## Exhibit 13

# Scenario #3 Ramp Restoration Options

The following is a summary of the Power Point presentation that was distributed at the January 23, 2004 Dan Ryan Taskforce Meeting. It is meant as a supplement to the materials to assist Taskforce Members in understanding the various proposals for the ramp configurations.

#### 47th - 43rd Street (Restore south half of 43rd street interchange) - Alternate A

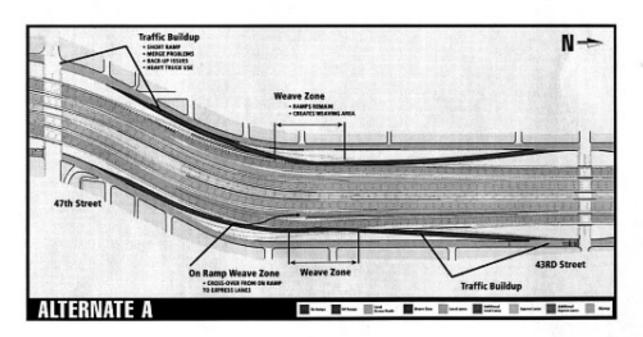
- Direct access to and from the Dan Ryan at 43<sup>rd</sup> Street.
- Reduces traffic on the frontage roads between 43<sup>rd</sup> and 47<sup>th</sup> Street.

- Requires shifting the northbound and southbound exit ramps toward 43<sup>rd</sup> and 47<sup>th</sup> Street, causing potential traffic buildup on all ramps and a weave zone from the exit ramps to the right turn lanes at the intersections.
- Proposed northbound weaving zone is below engineering standards.
- Potential safety issue because access from the northbound 47<sup>th</sup> Street entrance ramp to the express lane slip ramp will not be physically blocked.
- Moderate cost increase.

# 47<sup>th</sup> – 43<sup>rd</sup> Street (Restore south half of 43<sup>rd</sup> street interchange) – Alternate B (Flopped ramps)

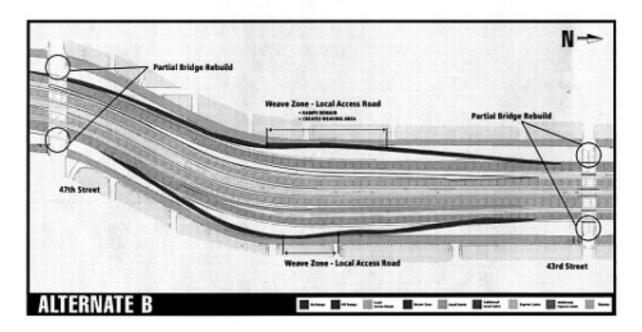
- Direct access to and from the Dan Ryan at 43<sup>rd</sup> Street.
- Weave zones transferred to lower speed frontage roads.

- Reconstruct 43<sup>rd</sup> and 47<sup>th</sup> Street bridges to accommodate reconfigured ramps and provide safe sight distance.
- Potential safety issue since access from the southbound 43<sup>rd</sup> Street entrance ramp to express lane slip ramp is not physically blocked.
- Southbound frontage road weave is below engineering standards.
- Substantial cost increase due to bridgework and the movement of ramps.

#### 51st - 47th Street (Restore north half of 51ST street interchange) - Alternate A

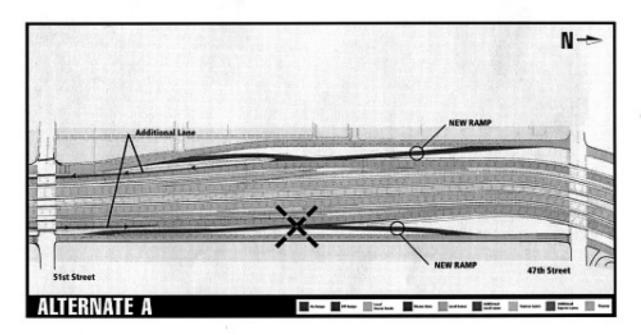
- Northbound ramps overlap each other providing no weaving area, which is NOT acceptable.
- Proposed southbound weave section is below engineering standards.
- Potential safety issue since access from the southbound 47<sup>th</sup> Street entrance ramp to the
  express lane slip ramp is not physically blocked.
  - \*Alternate A is NOT considered feasible based on the issues listed above and the two new ramp additions proposed for 47<sup>th</sup> Street\*

#### 51st - 47th Street (Restore north half of 51st street interchange) - Alternate B

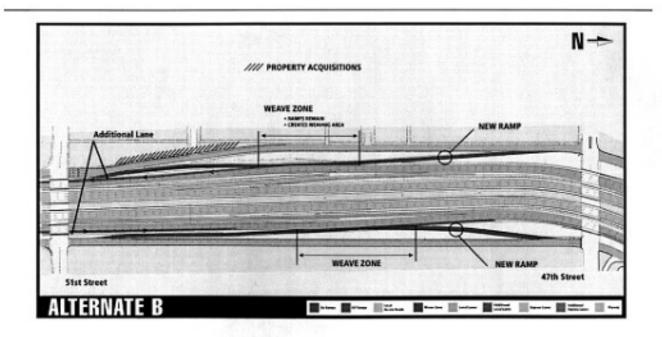
- Direct access to and from the Dan Ryan at 51<sup>st</sup> Street.
- Direct access for trucks exiting at 47<sup>th</sup> Street to the intermodal yard.
- Reduces traffic on the frontage roads between 47<sup>th</sup> Street and 51<sup>st</sup> Street.

- The northbound 47<sup>th</sup> Street exit ramp conflicts with the intersection, causing potential traffic build up on the ramps and a dangerous weave zone from the ramp to the right lane at the 47<sup>th</sup> street intersection.
- Potential safety issue since access from the southbound 47<sup>th</sup> Street entrance ramp to the express lane slip ramp is not physically blocked.
- Southbound frontage road (Wells Street) with the new alignment requires the acquisition of property (residential) and a building displacement, which can take up to 18 months to finalize and will delay the project significantly.
- Potential accident rate increase due to less than standard weave zone.
- Moderate construction cost increase.

#### 55th - 51st Street (Restore south half 51ST street interchange) - Alternate A

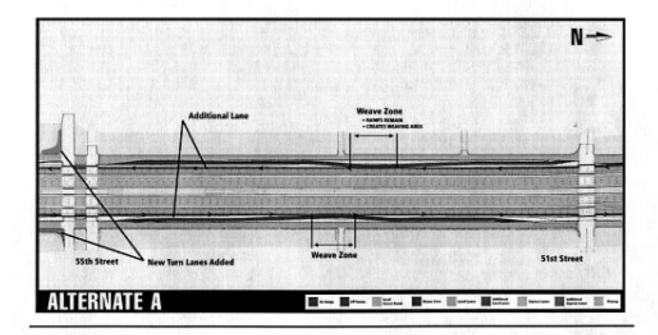
- With added 3<sup>rd</sup> local lane and a narrow corridor width in this area, the ramp weaves are reduced significantly from 820' to 280', which is unacceptable and a potential safety issue.
- Proposed northbound and southbound weaving between ramps is below engineering standards.
- Potential safety issue with a fixed object near the northbound and southbound exit ramps due to a narrow corridor width.
  - \* Alternative A is NOT considered feasible based on the issues listed above\*

#### 55th - 51st Street (Restore south half of 51st street interchange) - Alternate B

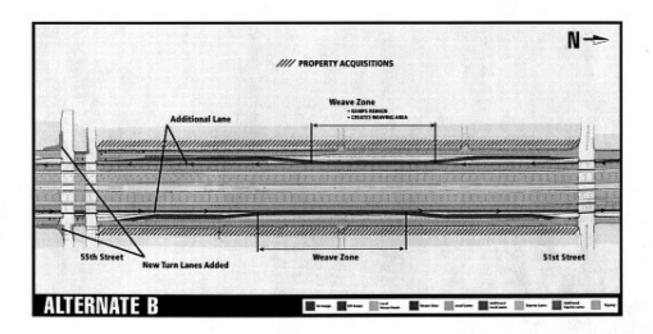
- Direct access to and from the Dan Ryan at 51<sup>st</sup> Street and direct access for trucks exiting northbound at 47<sup>st</sup> Street to the intermodal yard.
- Reduces traffic on the frontage roads between 47<sup>th</sup> and 51<sup>st</sup> Street.

- Northbound and southbound exit ramps conflict with the intersection queue causing
  potential traffic build up on the ramps and a difficult weave maneuver from the ramp to the
  right turn lane at the intersection.
- Realignment of the Wells and Wentworth frontage roads is required.
- Significant construction cost increase.
- New property acquisition and multiple building displacements cause significant project delay.

#### 59th - 55th Street (Restore north half of street interchange) - Alternate A

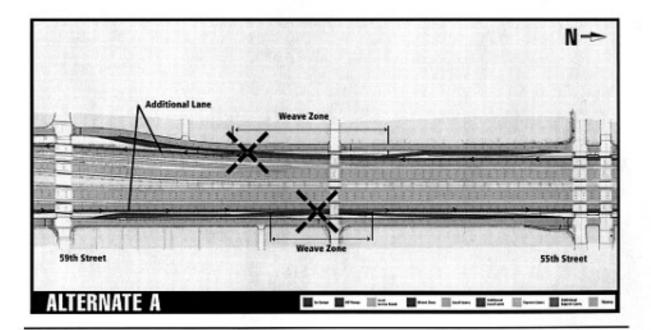
- With added 3<sup>rd</sup> local lane and narrow corridor width in this area, there is no remaining room between local lanes and the frontage road to accommodate southbound 59<sup>th</sup> Street exit ramp.
- Proposed northbound ramps overlap, providing no weaving area, which is unacceptable.
  - \*Alternative A is NOT considered feasible based on the issues listed above\*

#### 59th - 55th Street (Restore north half of 59th street interchange) - Alternate B

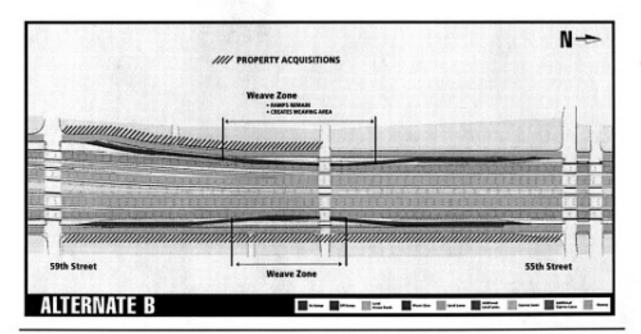
- Direct access to and from the Dan Ryan at 59<sup>th</sup> Street.
- Reduces traffic on frontage roads between 59<sup>th</sup> and 55<sup>th</sup> Street.

- Northbound and southbound exit ramps conflict with the intersection queues causing
  potential traffic buildup on the ramps and a difficult weave zone from the ramp to the right
  turn lane at the intersection.
- Realignment of the Wells and Wentworth frontage roads is required.
- Significant construction cost increase.
- New property acquisition and multiple building displacements causing significant project delay.

#### 63rd - 59th Street (Restore south half of 59th street interchange) - Alternate A

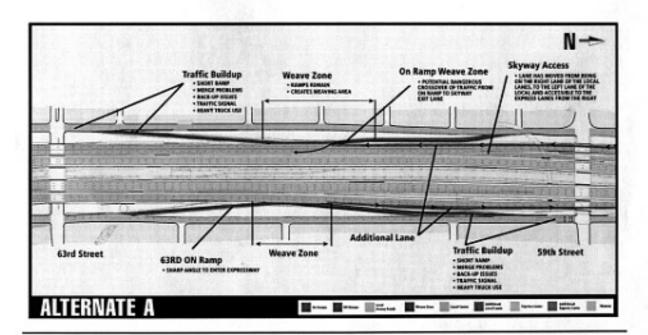
- Direct access to and from the Dan Ryan at 59<sup>th</sup> Street.
- Reduces traffic on frontage roads between 59<sup>th</sup> and 67<sup>th</sup> Street.

- Northbound and southbound exit ramps shifted closer to 59<sup>th</sup> and 63<sup>rd</sup> Streets, which
  causes potential traffic buildup on the ramps and a difficult weave zone from the ramp to
  the right turn lane at the intersection.
- Northbound weaving between ramps is below engineering standards.
- Reintroduces weave from southbound 63<sup>rd</sup> Street entrance ramp to Skyway exit ramp.
- Moderate construction cost increase.

# 63<sup>rd</sup> – 59<sup>th</sup> Street (Restore south half of 59<sup>th</sup> street interchange) – Alternate B (Braided Ramps)

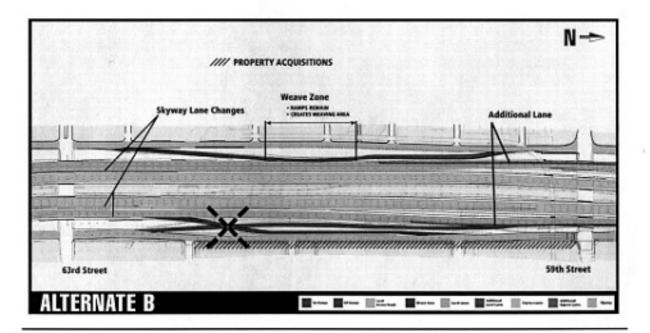
- Due to a limited distance between the Conrail RR structure and the CTA structure, braiding (over/under) the ramps is not possible.
- Ramp braiding requires severe bridge skew, which is undesirable and costly.
  - \*Alternative B is NOT considered feasible based on the issues listed above\*
